From: Andrew Jones [REDACTED]
Sent: 03 October 2023 19:21
To: Palmer, Leanne
Cc: David Periam
Subject: Appeal Reference APP/U3100/V/23/3326625 - HIF1 Roads Projects, Oxfordshire
Attachments: HIF1Objections.pdf; DidHIF1rev.pdf; Didcot1C.pdf; CycleBridge.pdf

HIF1 Roads Projects

Didcot and Thames Bridge

Cycle Bridge

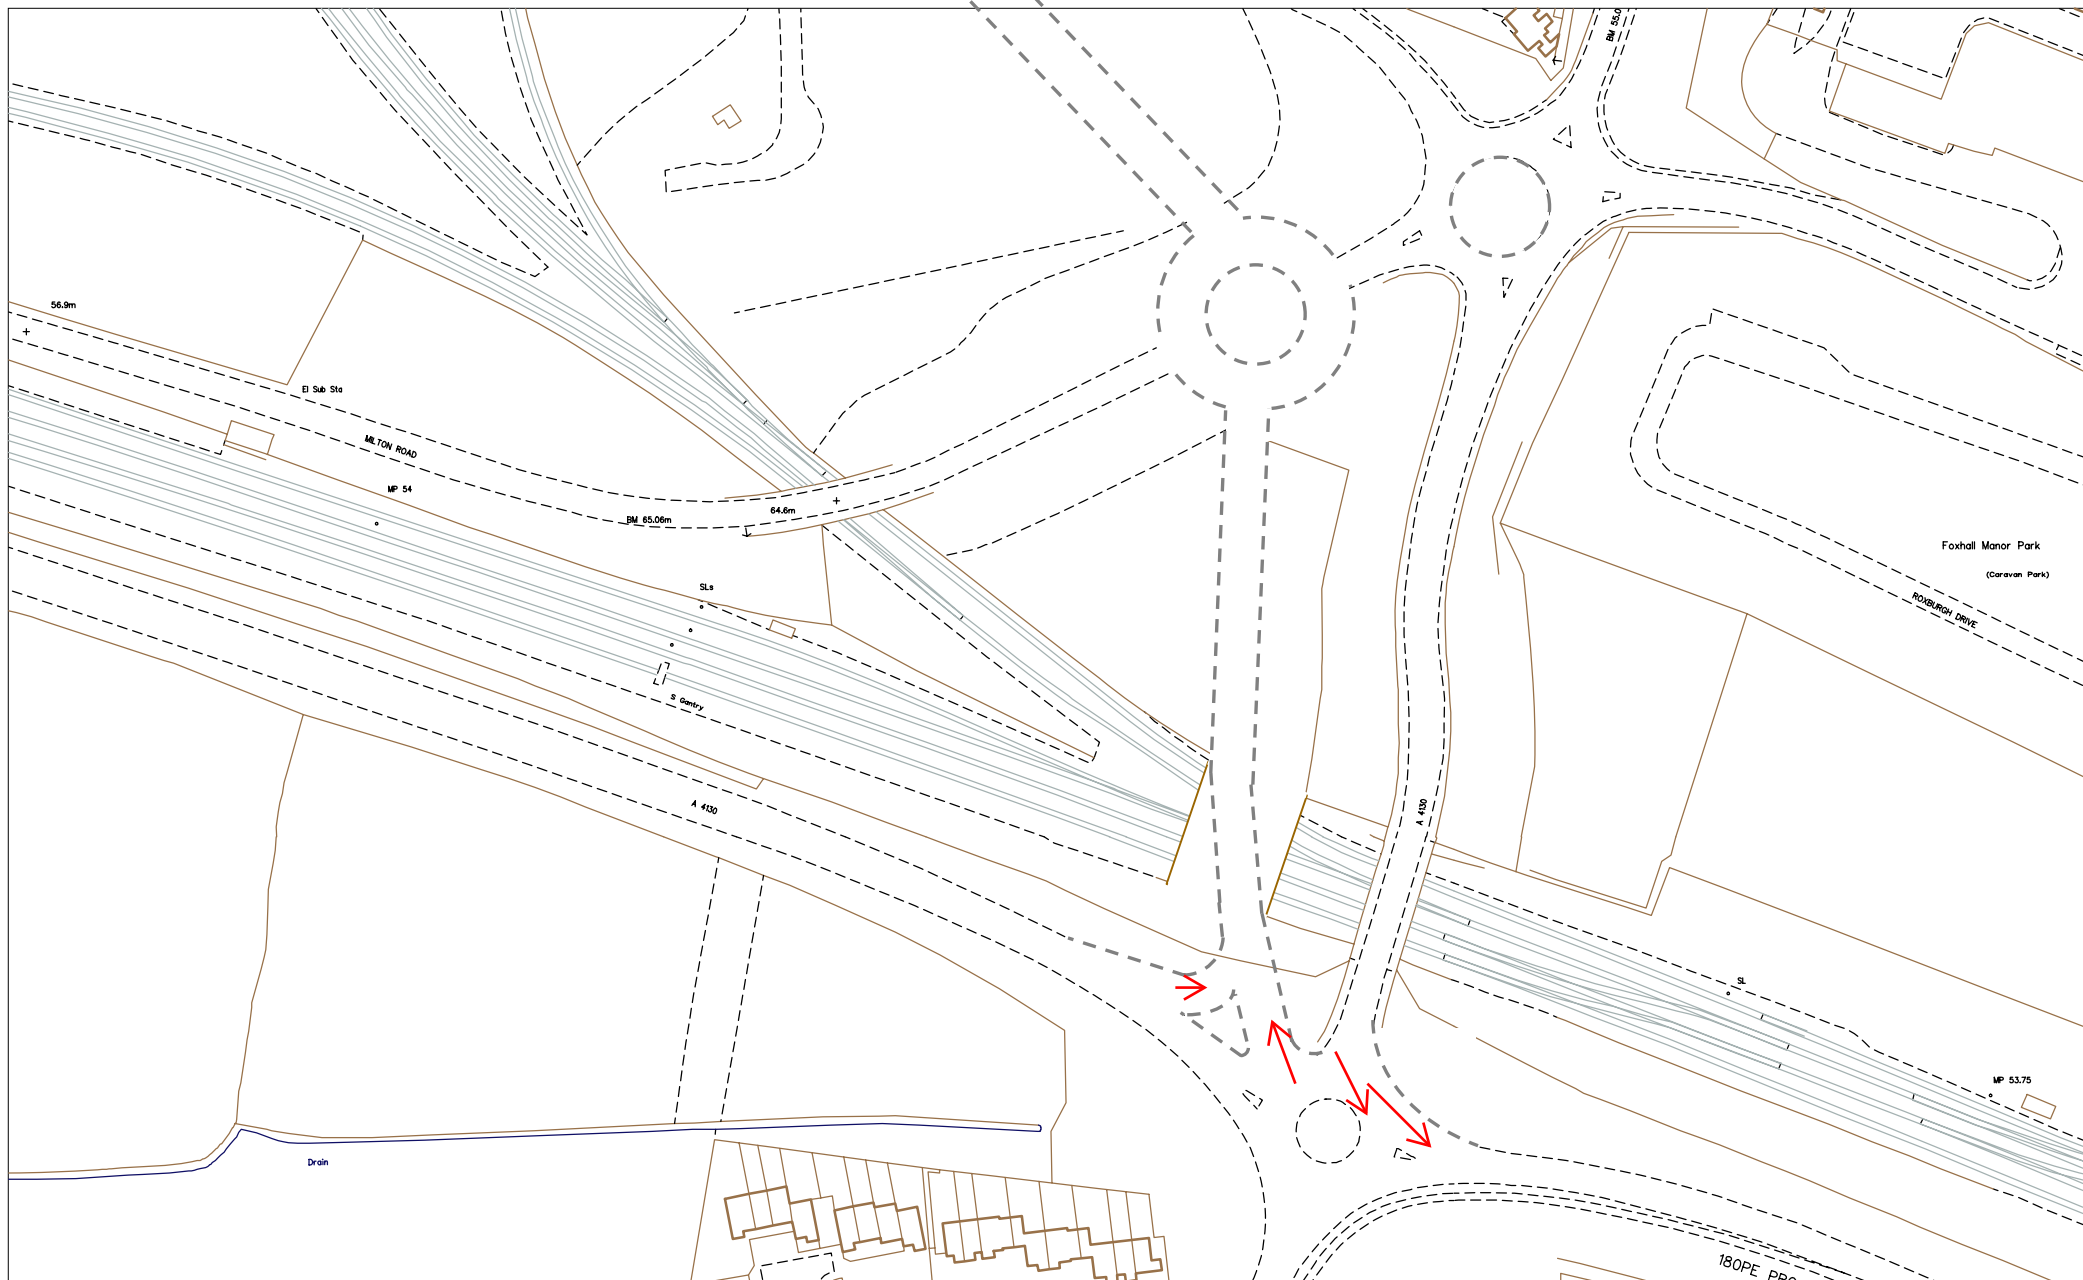
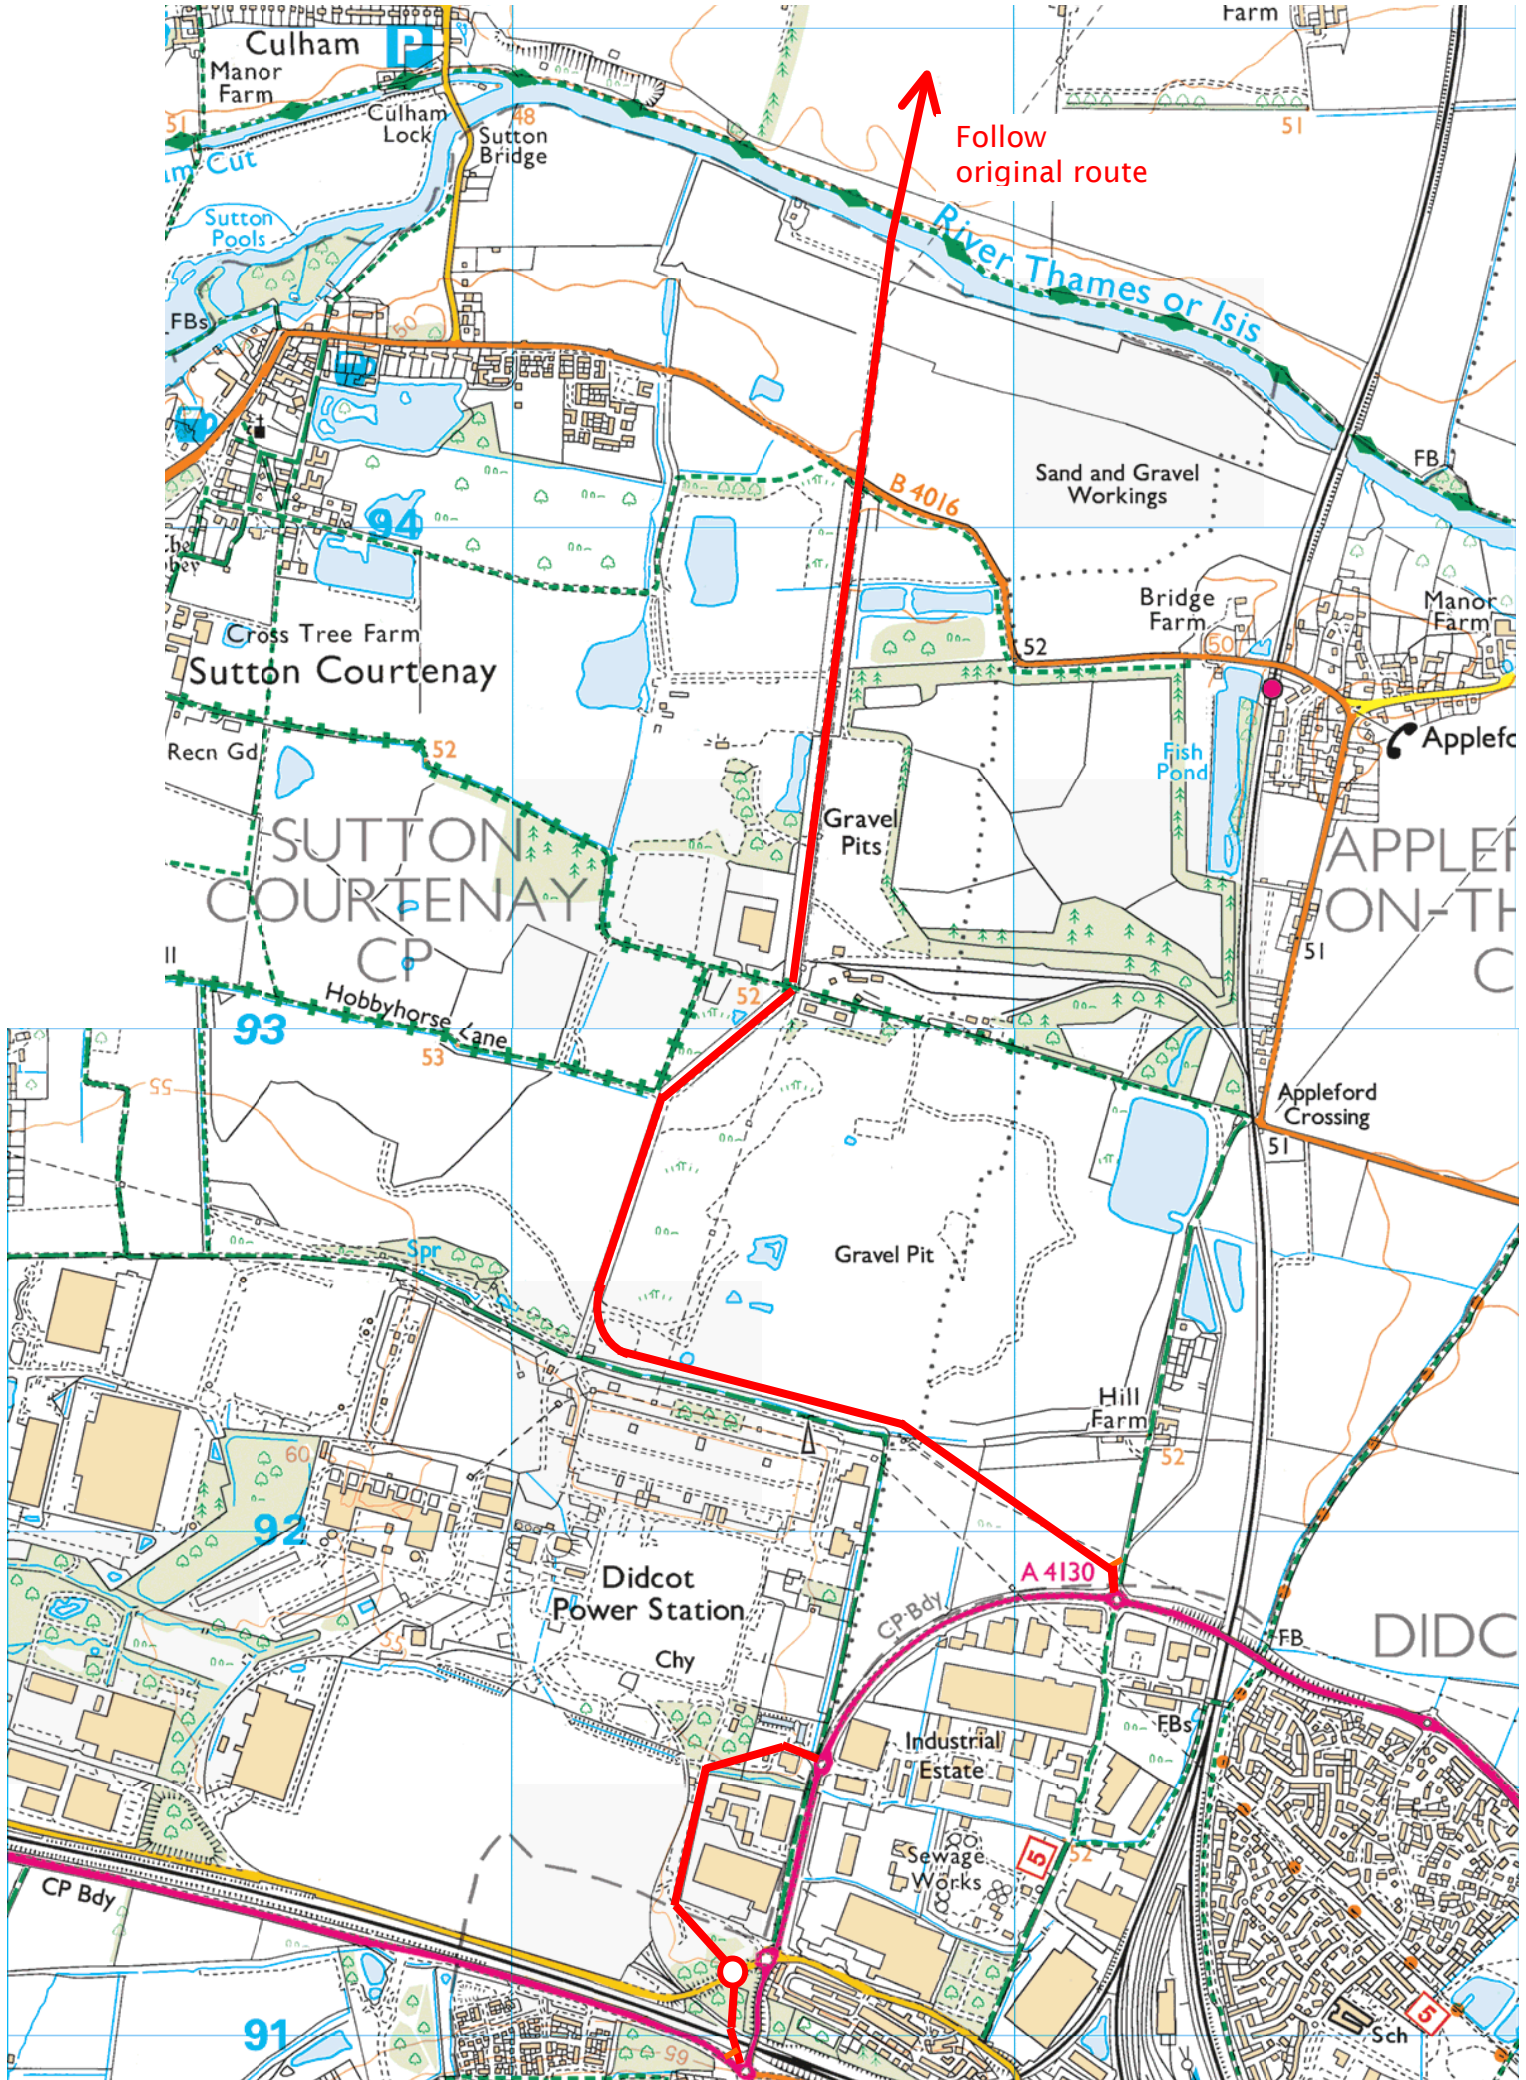
The Green line is a possible high-level Foot and Cycle Bridge, with shallow ramps, across the junctions

Cycle and pedestrian routes especially at the roundabout on the South side of the railway, are bad. I propose a cycle and foot bridge over this junction. (See CycleBridge.pdf green lines) Along, parallel to the B4493, a long ramp should provide a gentle slope to users from the direction of the railway station and 'Old Didcot'. Users from Mendip Heights would have a short level 'ramp' (as the ground is high), and would include users from the Freeman Road, Brasenose Road and Slade Road area, along with users from the East side of Great Western Park and the Park Road area. There should also be some cycle and pedestrian provision and improvements around the existing A4130.
